## HISTORIC AND DESIGN REVIEW COMMISSION

### Agenda Item No: 21

**HDRC CASE NO:** 2016-203  
**ADDRESS:** 431 ADAMS ST  
**LEGAL DESCRIPTION:** NCB 2880 BLK 5 LOT 9  
**ZONING:** RM4 H  
**CITY COUNCIL DIST.:** 1  
**DISTRICT:** King William Historic District  
**APPLICANT:** Jorge Araujo  
**OWNER:** Scott & Hoda Cummings, Scott & Hoda Cummings  
**TYPE OF WORK:** Demolition of accessory structure and new construction  
**REQUEST:**

A2

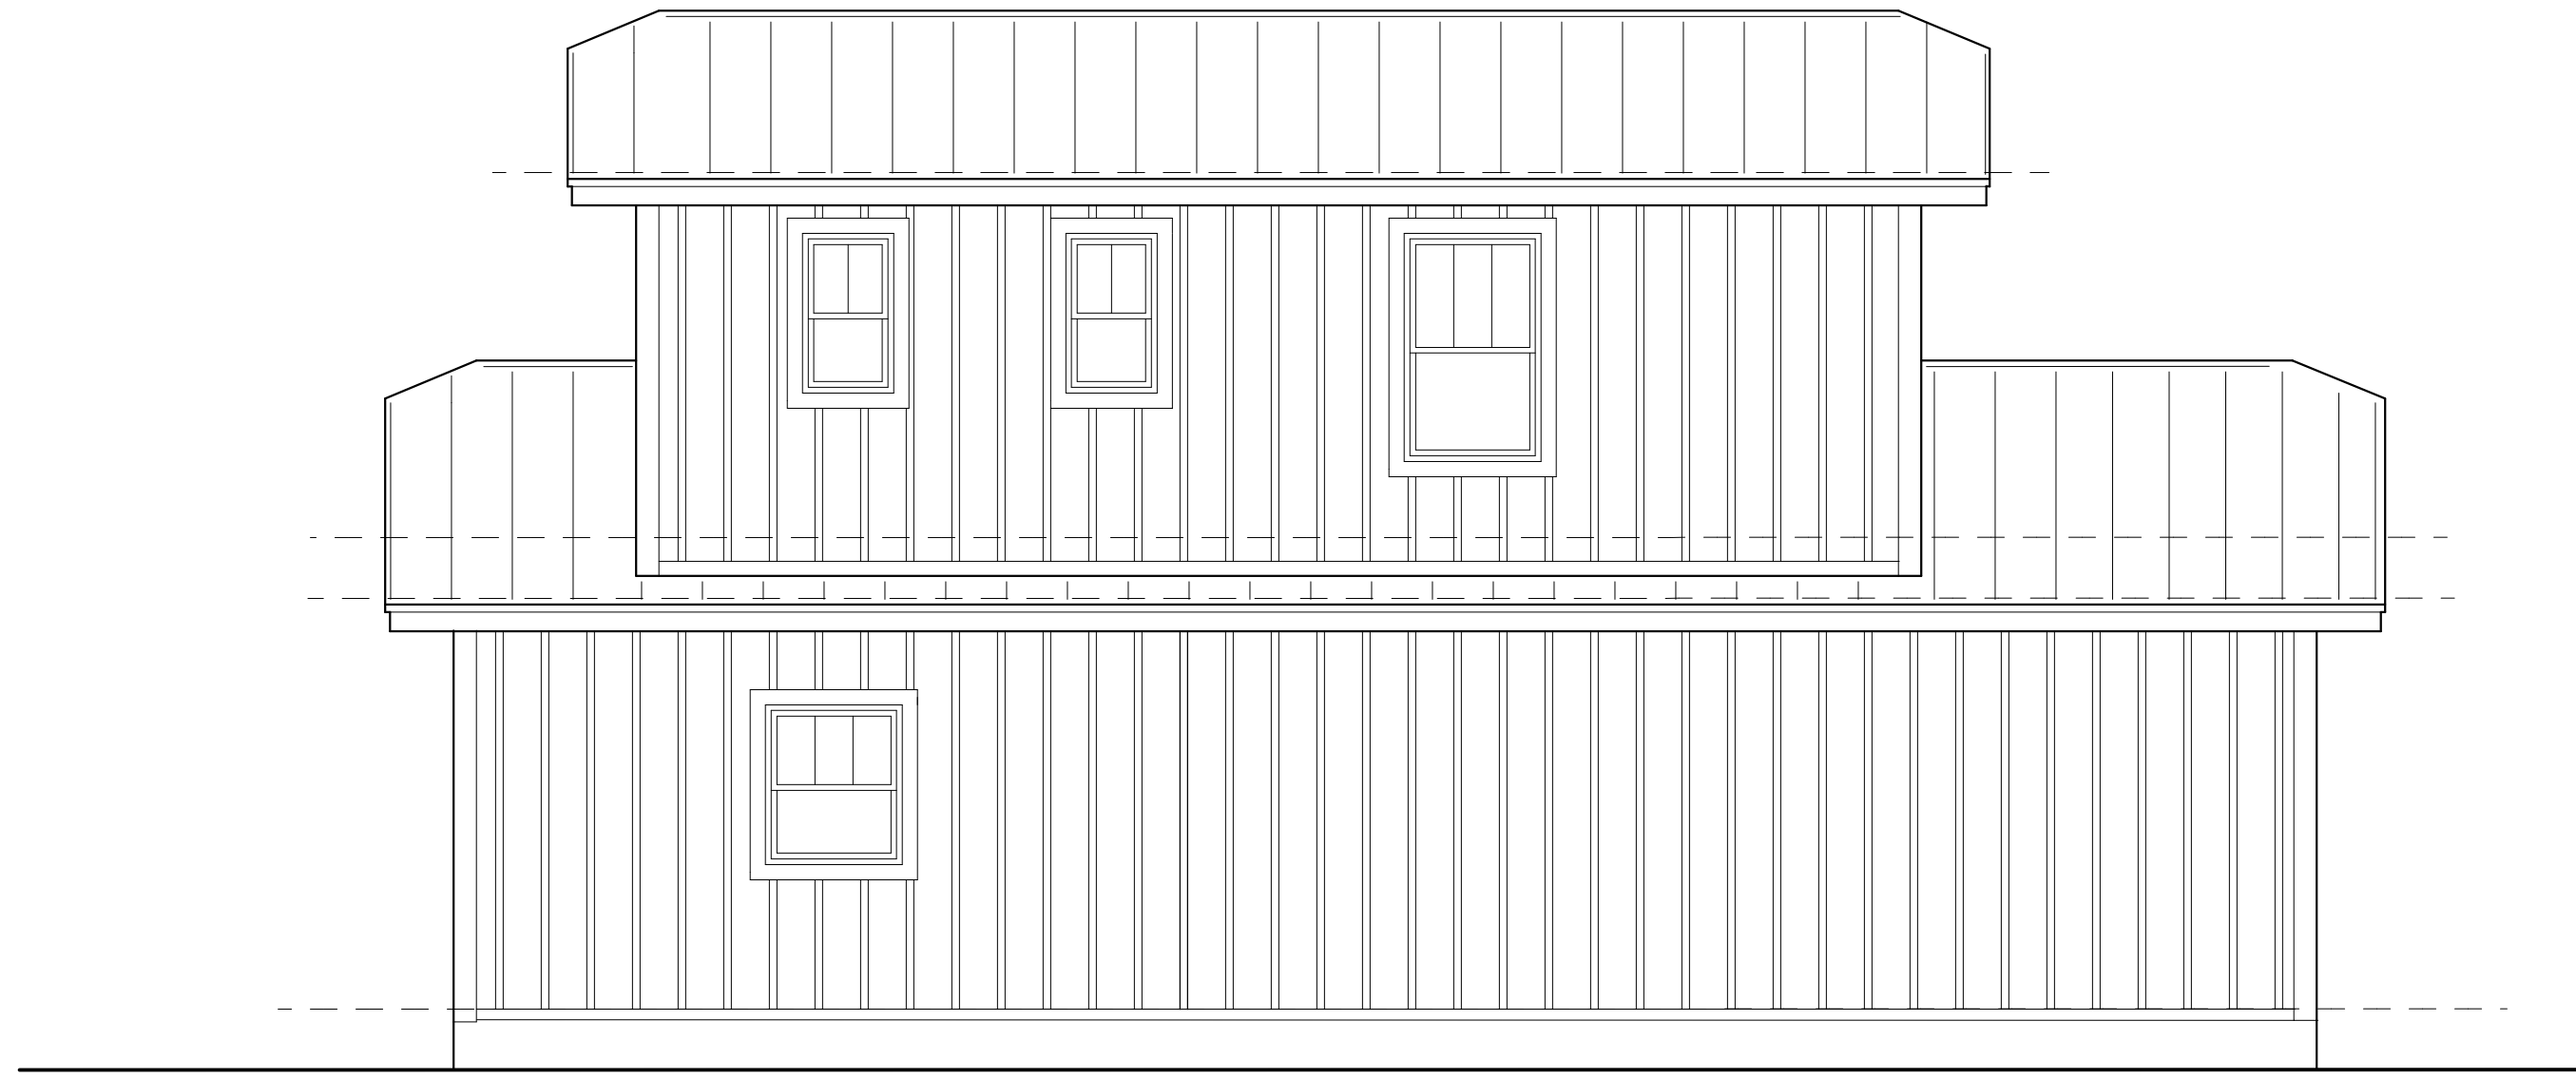
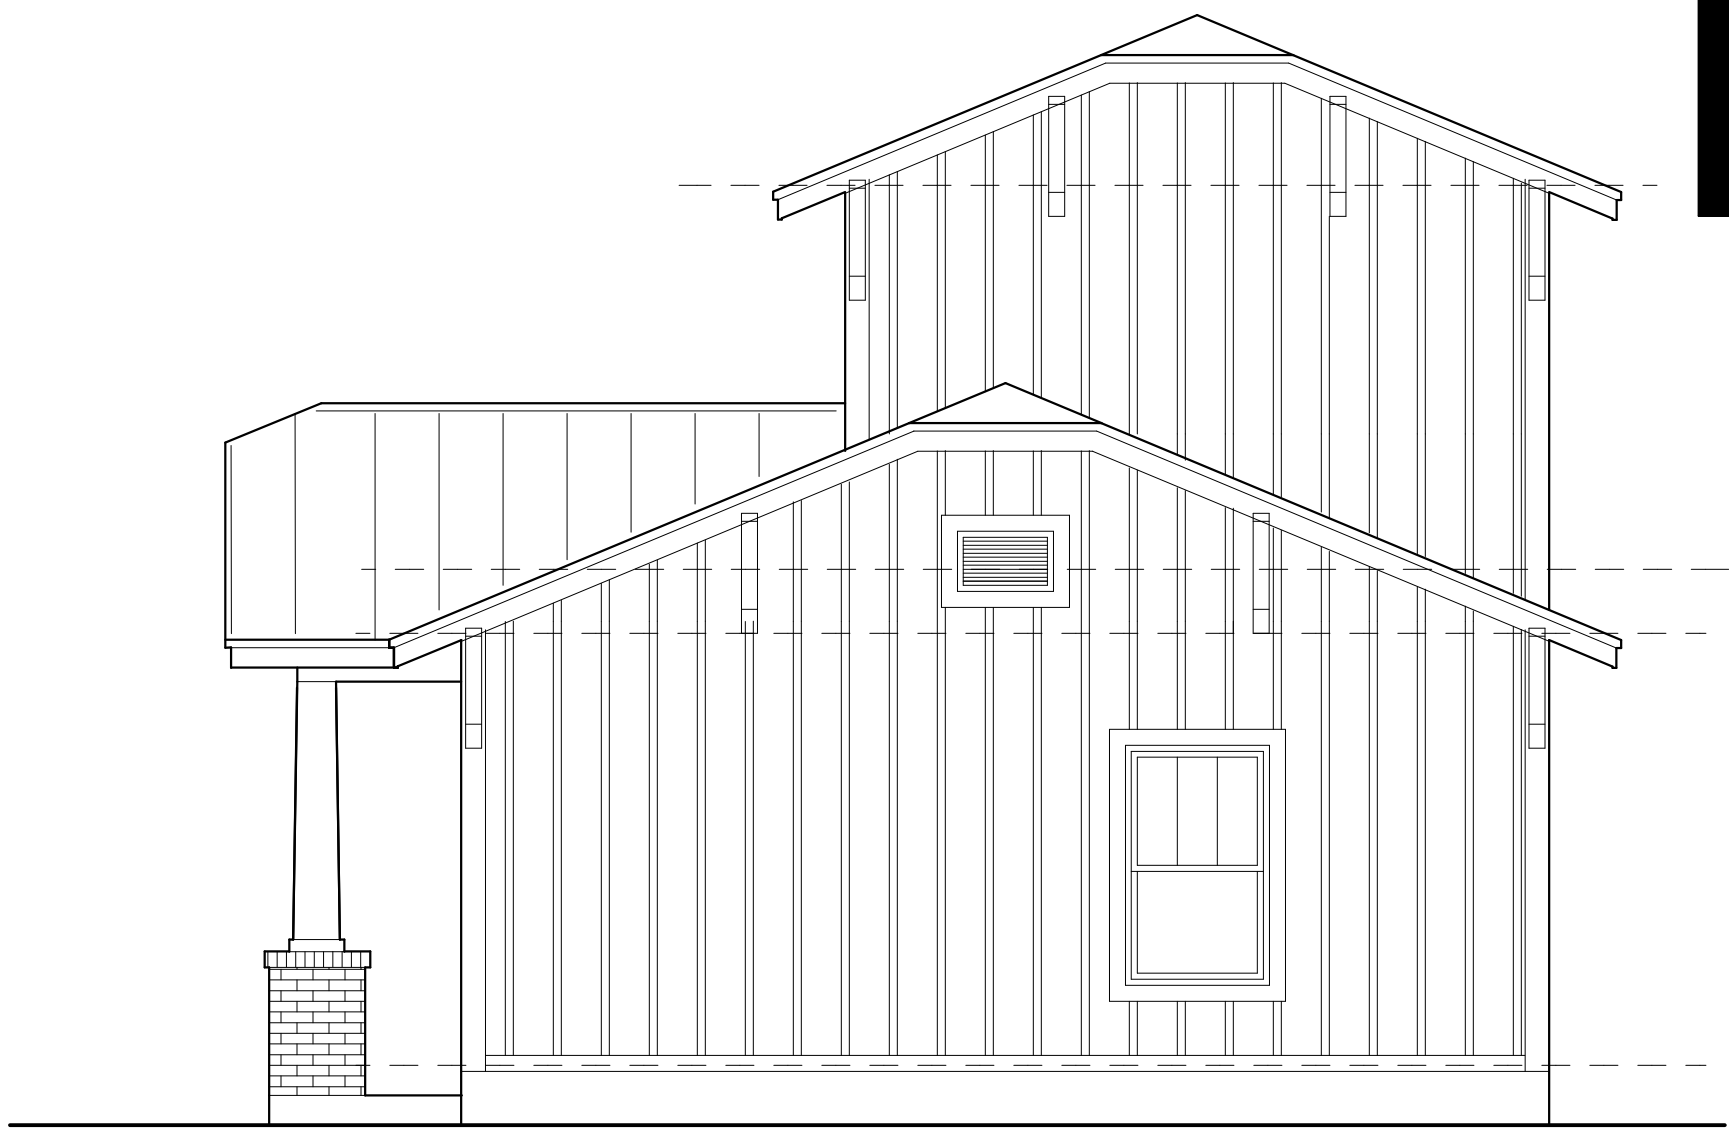
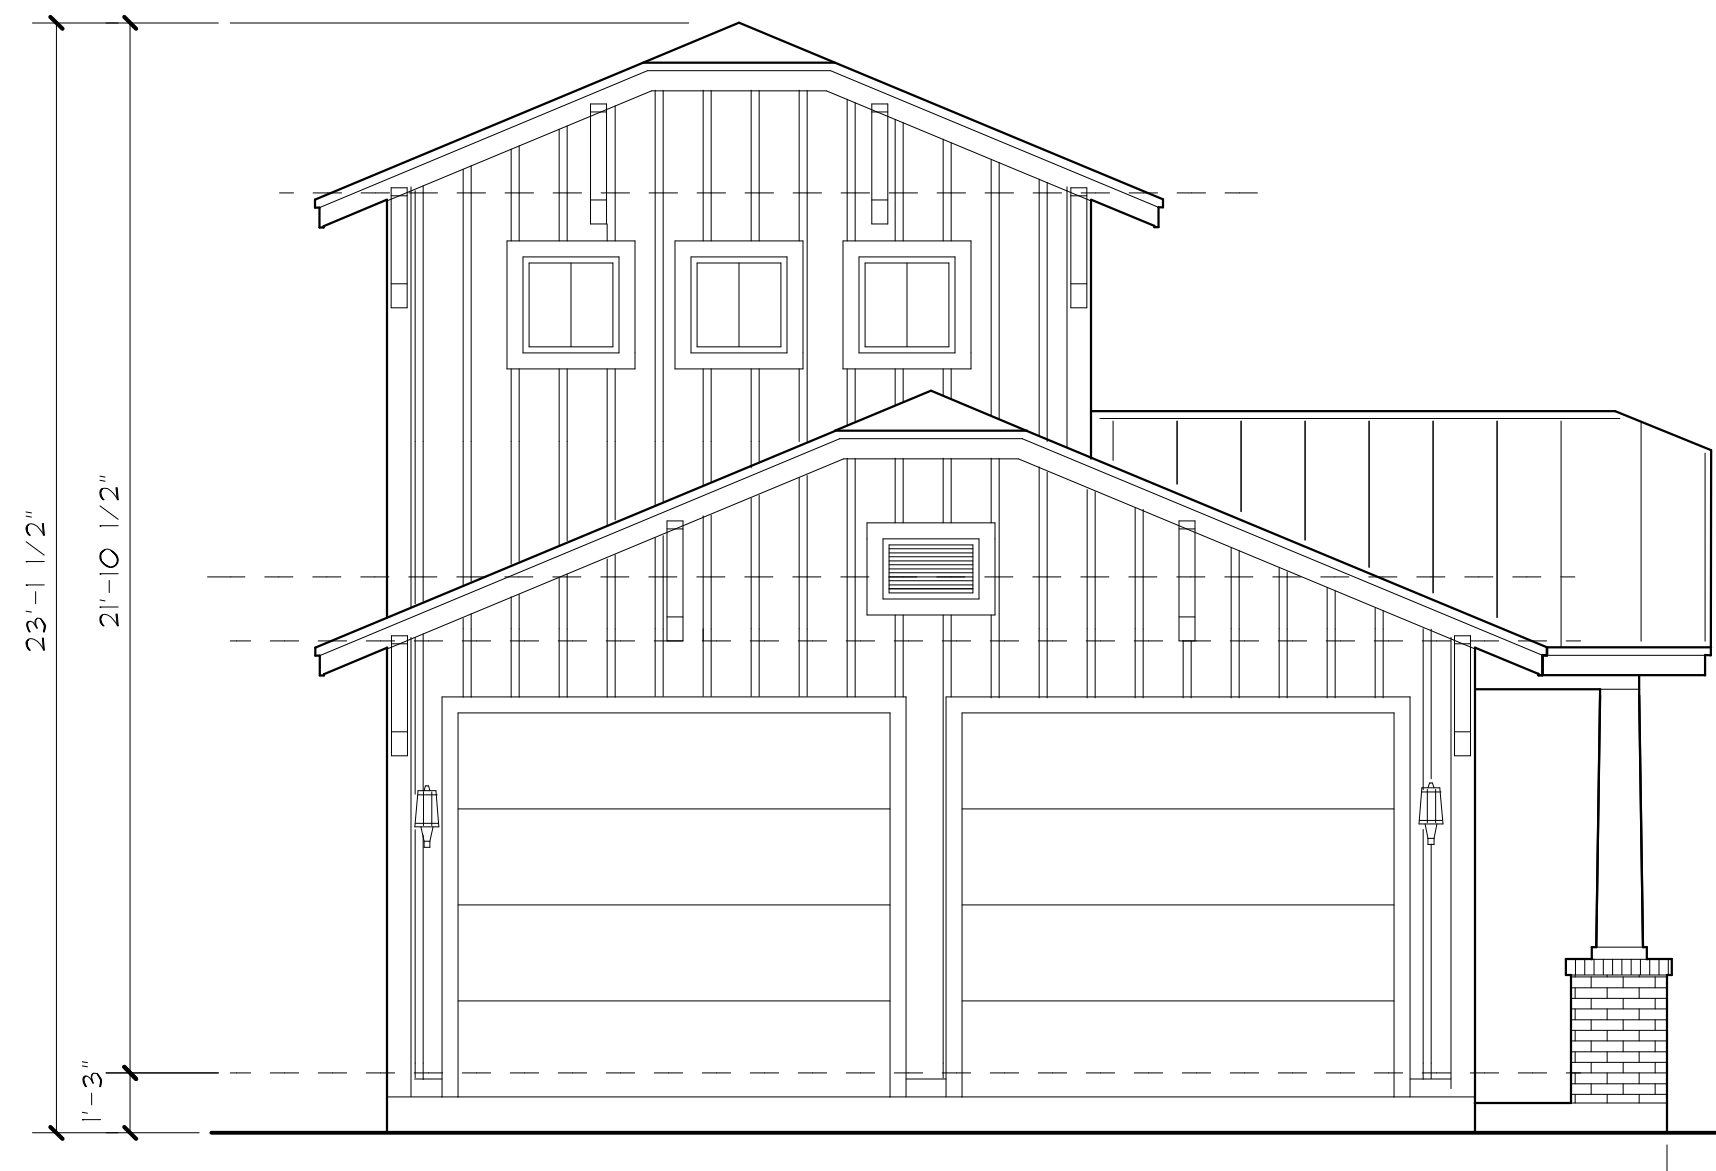
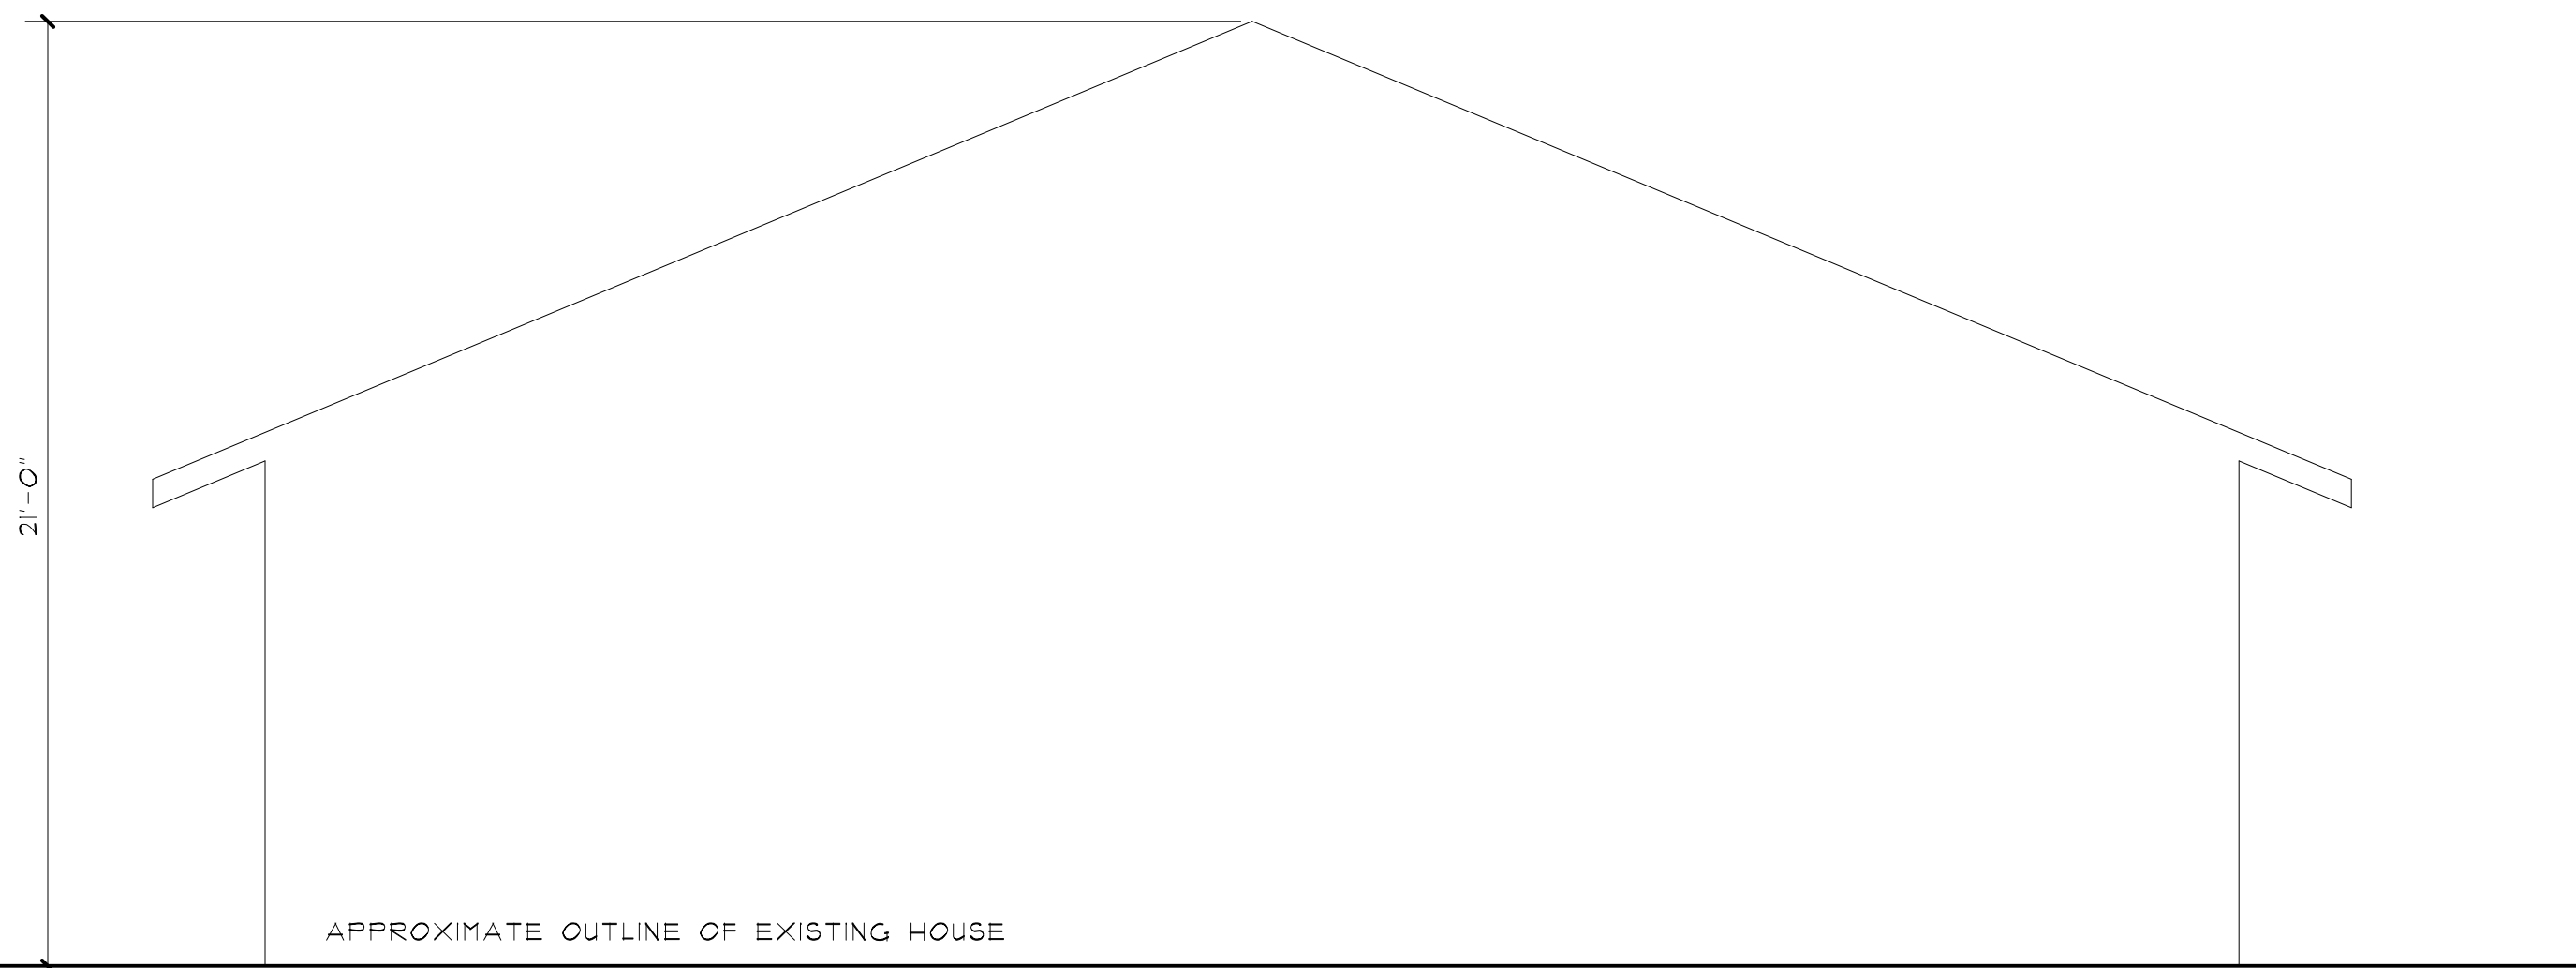
- c. **MASSING & FORM** – According to the Guidelines for New Construction 5.A.i, new accessory structures should be designed to be visually subordinate to the primary historic structure in terms of their height, massing and form. The primary historic structure at 431 Adams features a single story with a foundation height of approximately two feet and an overall height of 21' – 0". The applicant has proposed to construct an accessory structure to include two levels and an overall height of 23' – 1 ½". In terms of height, while the proposed structure is slightly taller than the primary historic structure, staff finds its height is generally appropriate in context with other accessory structures along both Adams and Barbe.

- f. **CHARACTER** – At this time, the applicant has proposed façade materials to include Hardi Board siding and brick consistent with the brick of the primary historic structure. The applicant however has proposed for vertically oriented siding for the accessory structure and has included craftsman style architectural elements on a structure that features a vertically oriented siding. This is architecturally inappropriate.

- g. **WINDOWS & DOORS** – The applicant has noted that the accessory structure is to feature aluminum windows that are to match the profile of the windows found in the primary historic structure. Staff finds that wood windows would be more appropriate. Each window should be inset within walls at least (2) inches. In regards to window placement, the applicant has proposed for the accessory structure to include walls that at times are void of fenestration of façade separation. This is neither appropriate nor consistent with the Guidelines. Staff recommends the applicant propose fenestration patterns that provide façade separation and negate long expanses of blank walls.

- h. **GARAGE DOORS** – In regards to the proposed garage doors, the applicant has not noted a specific material, however, staff finds that the applicant should study existing garage door found throughout the district that are architecturally contributing.

1. That the applicant reduce the proposed massing and footprint of the proposed accessory structure to be more appropriate for the primary historic structure.
2. That the address the architectural inconsistencies including siding orientation and the proposed garage doors.
3. That the applicant provide information in regards to the proposed windows including their installation.

4. That the applicant introduce additional windows or make other design changes to reduce the overall lack of fenestration.
